**Appendix A – Technical Memorandum No. 1 - Preliminary  
Data Review and Documentation of Technical Methods**

# TECHNICAL MEMORANDUM

**To:** Coachella Valley Salt and Nutrient Management Plan Technical Group      **Date:** October 16, 2014  
**From:** MWH      **Reference:** 10505158  
**Subject:** Technical Memorandum No.1 Preliminary Data Review and Documentation of Technical Methods

### **Stakeholder Comments and Response to Comments**

**Figure 5-2**

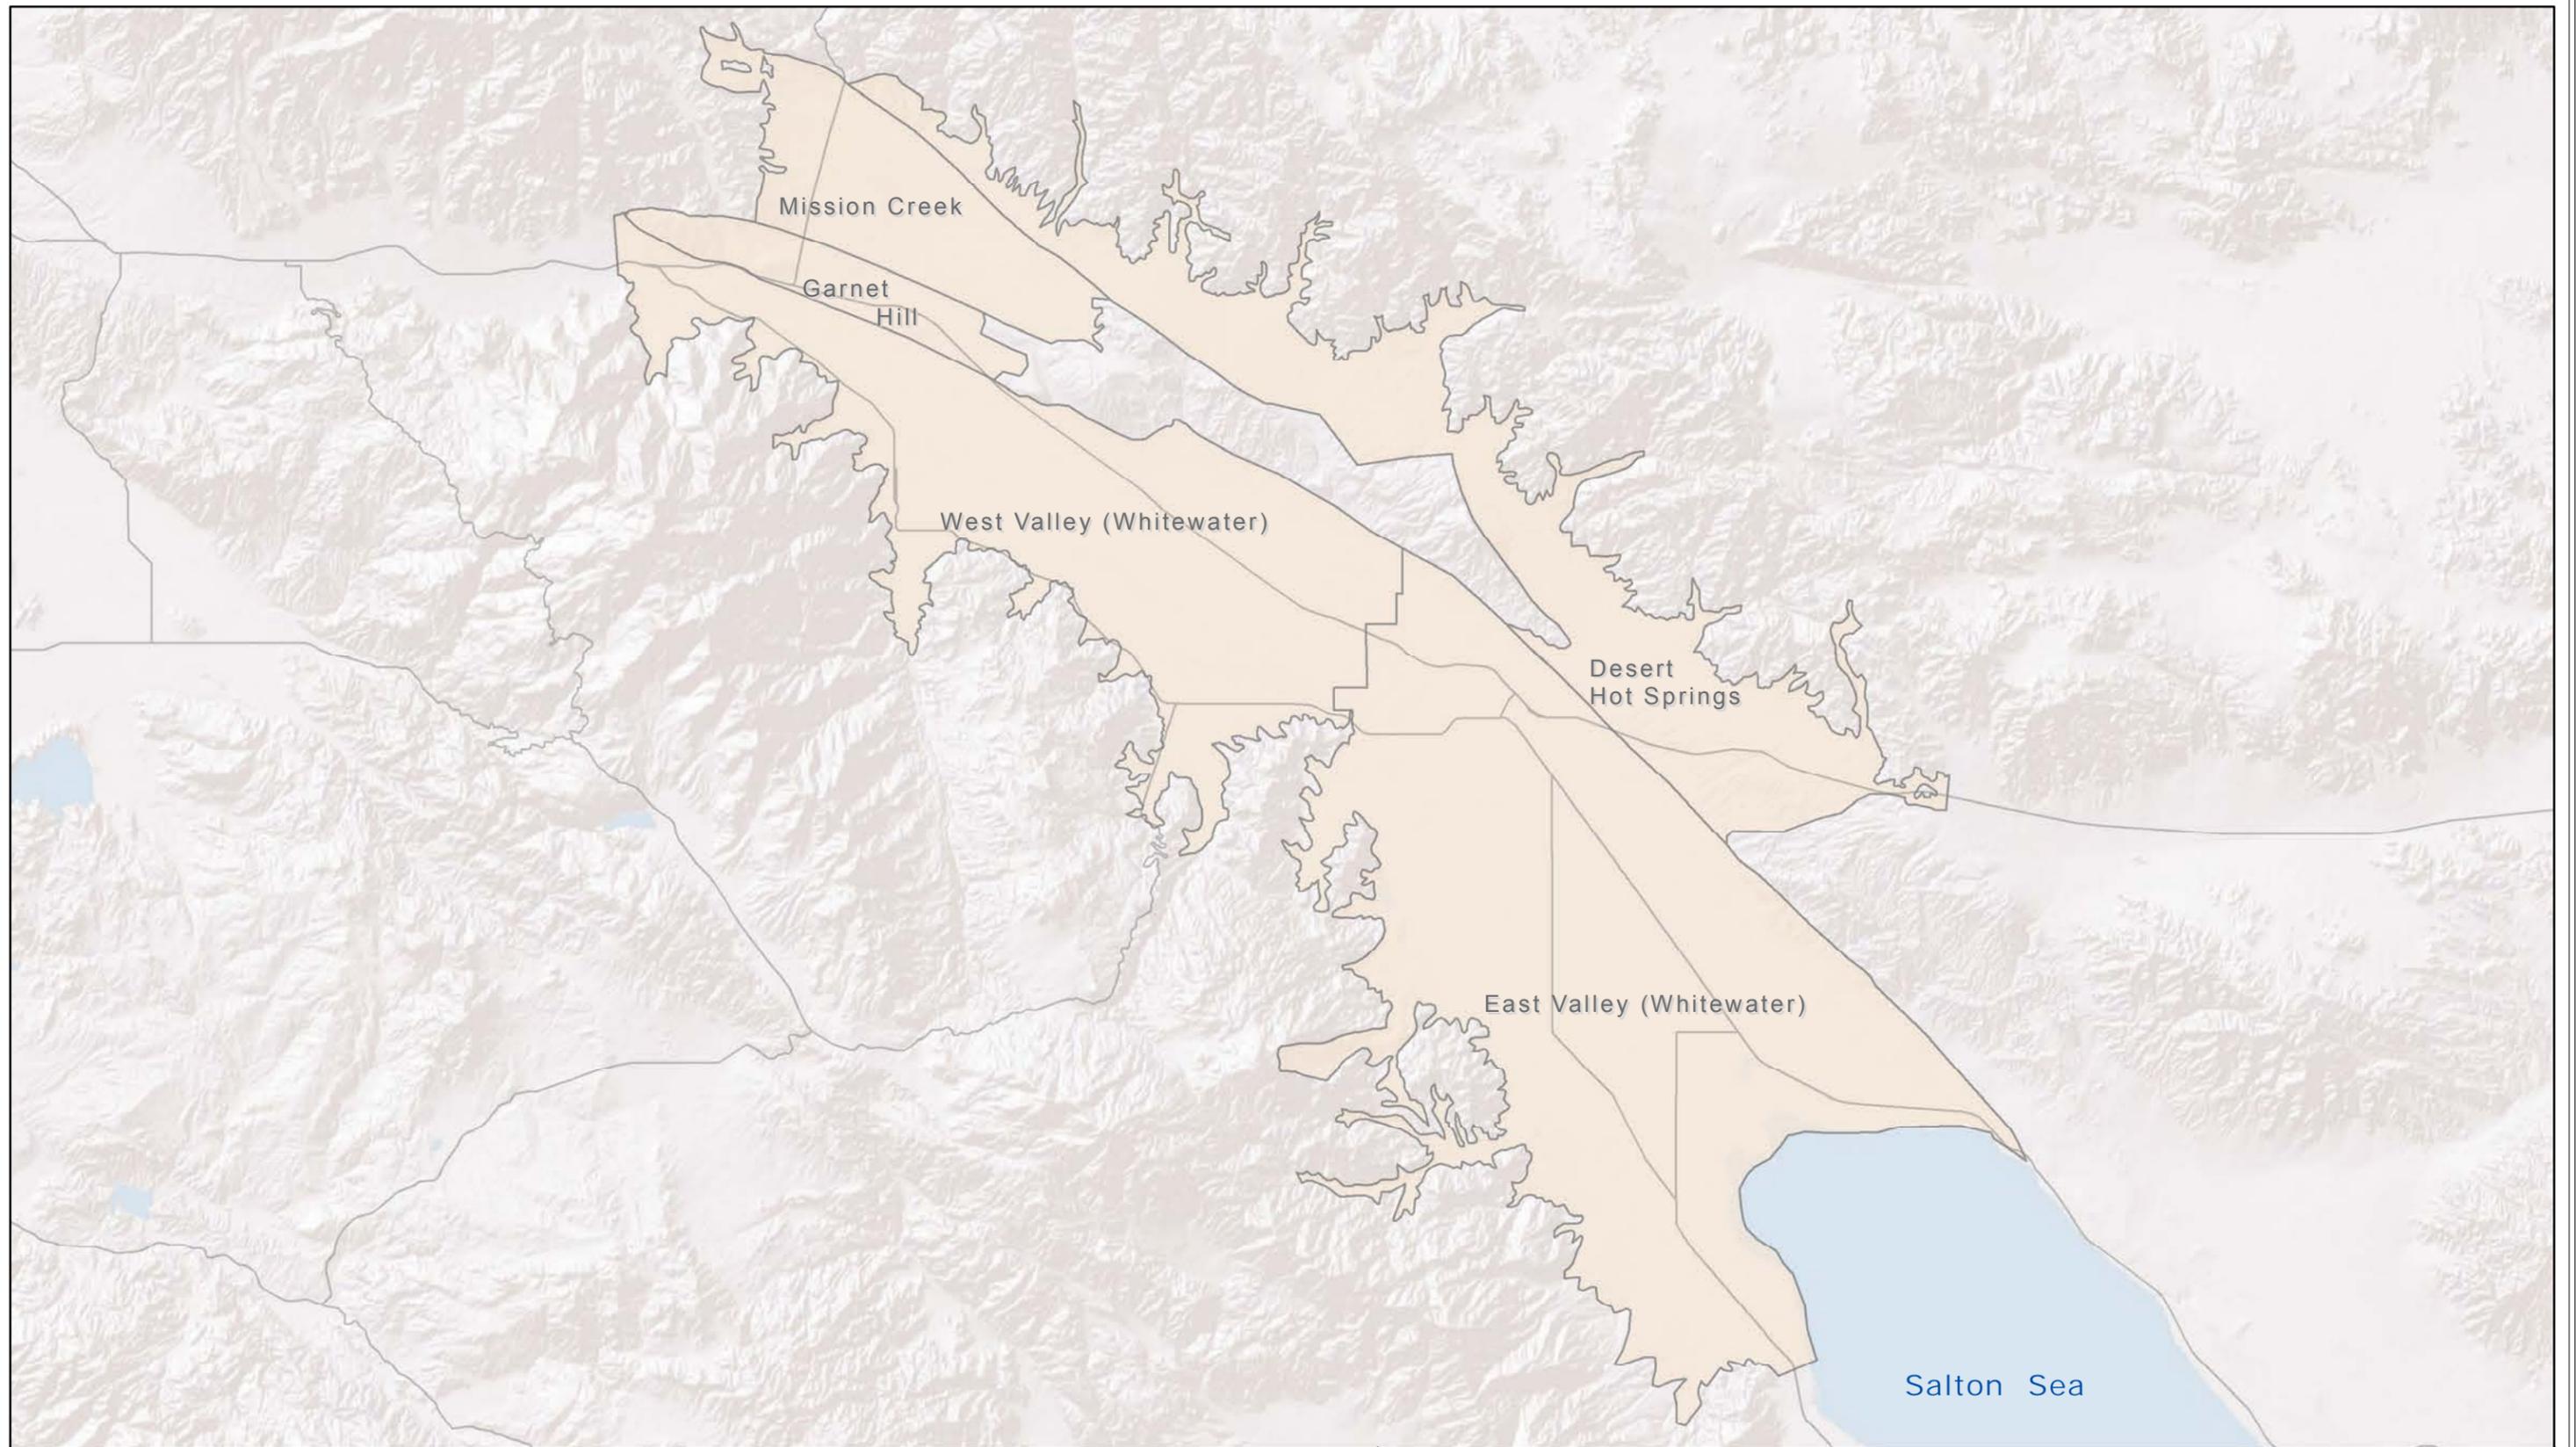
| Stakeholder   | No. | Comment   | Response   |
|---|-----|---|--|
|   | 35  | On page 59, Figure 5-2: the legend shows a symbol for highways but none are shown in the figure.  | Commented noted, the figure is modified to reflect the comment.  |
